MIL-P-63235(AR)
AMENDMENT 2
18 NOVEMBER 1982
SUPERSEDING
AMENDMENT 1
11 March 1980

MILITARY SPECIFICATION

PROJECTILE, GUIDED, 155MM, XM712
THERMAL BATTERY FOR

This amendment forms a part of Military Specification MIL-P-63235(AR), dated 31 August 1979, and is approved for use by the US Army Armament Research and Development Command and is available for use by all Departments and Agencies of the Department of Defense.

Figure 3. +30 Volt Power Source Voltage and Load Profiles (0 to 70 Seconds)

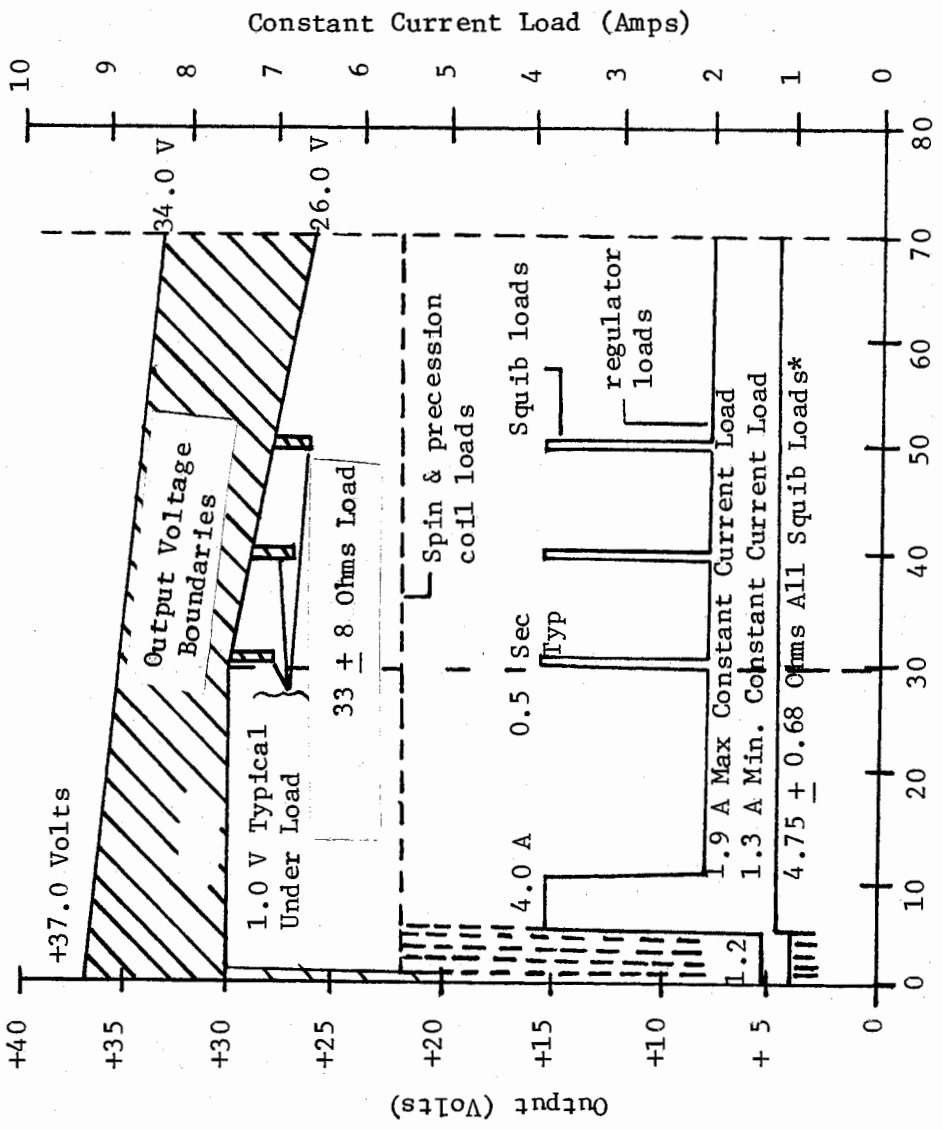
Delete Figure 3 entirely and substitute the attached Figure 3.

*Refer to paragraph 3.2.1.1.2.1 for times at which squib loads can occur, minimum voltage permissible during squib loads, and recovery time.

Figure 4. +30 Volt Power Source Voltage and Load Profiles (0 to 5.5 Seconds)
(Typical Squib Load Pattern Shown)

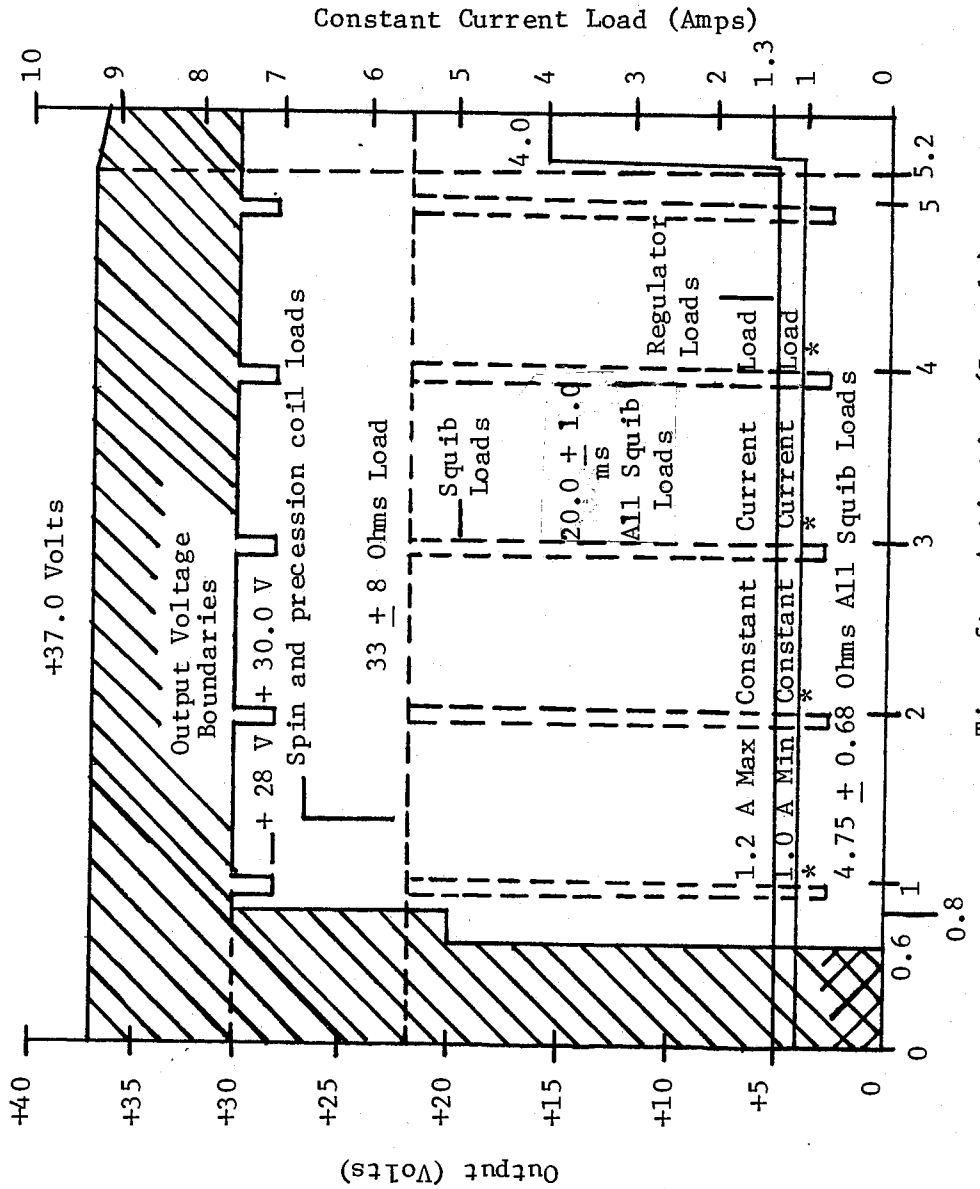
Delete Figure 4 entirely and substitute the attached Figure 4.

*Refer to paragraph 3.2.1.1.2.1 for times at which squib loads can occur, minimum voltage permissible during squib loads and recovery time.

Figure 5. -30 Volt Power Source Voltage and Load Profiles (0 to 70 Seconds)

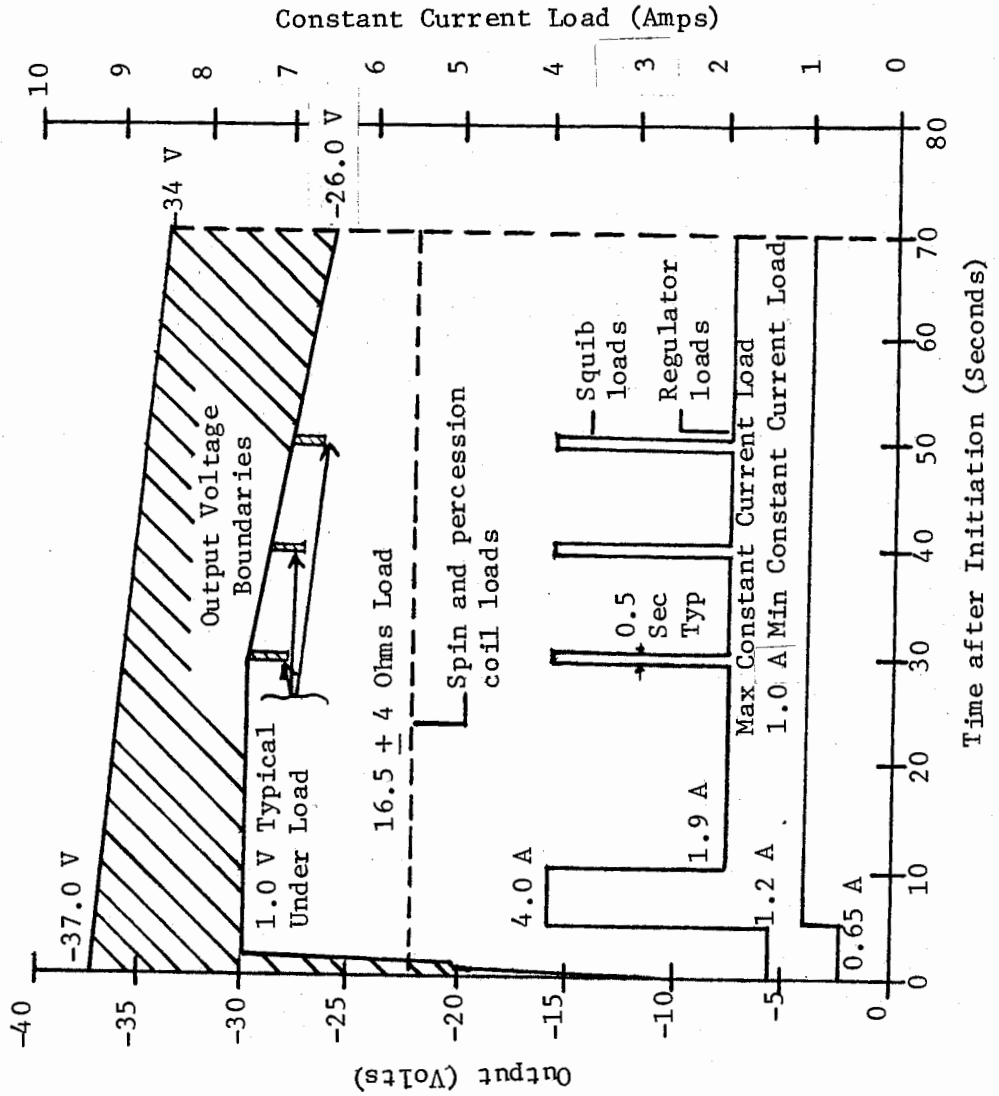
Delete Figure 5 entirely and substitute the attached Figure 5.

Figure 6. -30 Volt Power Source Voltage and Load Profiles (0 to 5.5 Seconds)

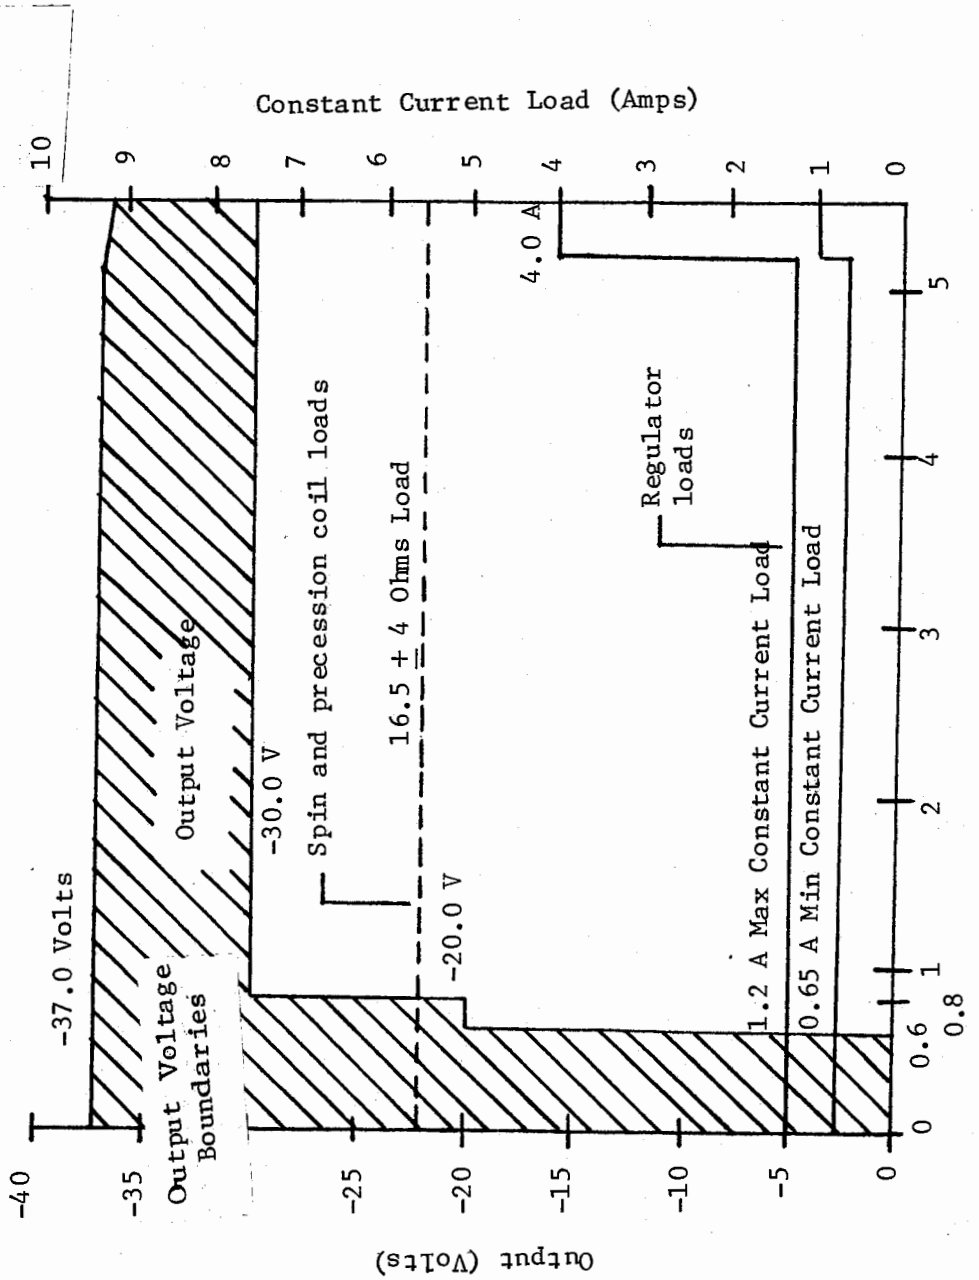
Delete Figure 6 entirely and substitute the attached Figure 6.
